Correspondence Between Staff and Applicant

RE: Determination of a Development Review Board hearing

RE: 50-DR-2011#2
QuikTrip #1418
6P757 (Key Code)

The Planning & Development Services Division has completed the review of the above referenced development application submitted on 7/2/2020. The following **4th Review Comments** represent the review performed by our team, and is intended to provide you with guidance for compliance with city codes, policies, and guidelines related to this application.

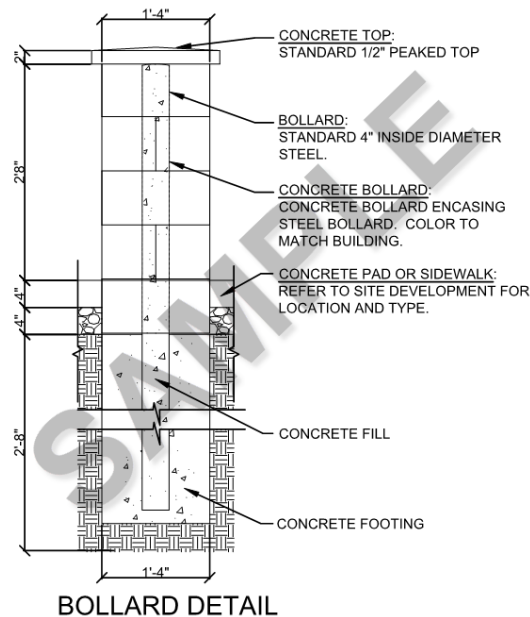
3. Although pipe bollards proposed were represented on the plans submitted for expired case 50-DR-2011, the approval included stipulations adopted by the Development Review Board regarding alternatives to be shown with the final plans submittal. Please revise the plans to reflect an alternative to the bollards that satisfies the previous stipulation which read:

Modify the bollards on 5-foot centers that are shown on the east, south, and west sides of the convenience store building. Instead of pipe bollards surrounding the building and at the base of the canopy columns, utilize large pots or raised planters for

landscape installations, or decorative bollards or metal work so that the barrier system will be less utilitarian in appearance, to the satisfaction of the Current Planning Director. If landscape installations are implemented, provide an opening in the concrete slab so that plant roots can access the soil at ground level.

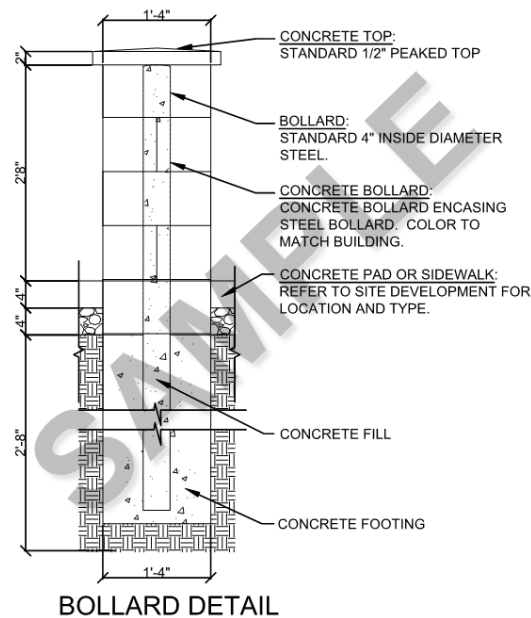
2. Although pipe bollards were represented on the plans submitted for expired case 50-DR-2011, the approval included stipulations adopted by the Development Review Board regarding alternatives to be shown with the final plans submittal. Please revise the plans to reflect an alternative to the bollards that satisfies the previous stipulation which read:

Modify the bollards on 5-foot centers that are shown on the east, south, and west sides of the convenience store building. Instead of pipe bollards surrounding the building and at the base of the canopy columns, utilize large pots or raised planters for landscape installations, or decorative bollards or metal work so that the barrier system will be less utilitarian in appearance, to the satisfaction of the Current Planning

Director. If landscape installations are implemented, provide an opening in the concrete slab so that plant roots can access the soil at ground level.

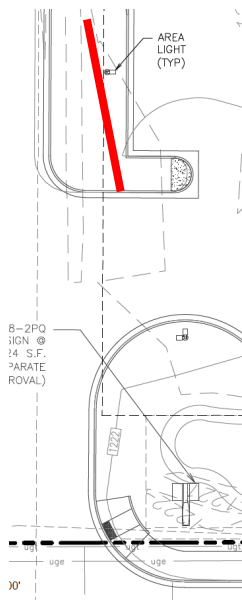
35. Please revise the site plan to identify the dedication of safety triangle easements at both site driveways, in accordance with DSPM 5-3.123; Fig. 5-3.27.
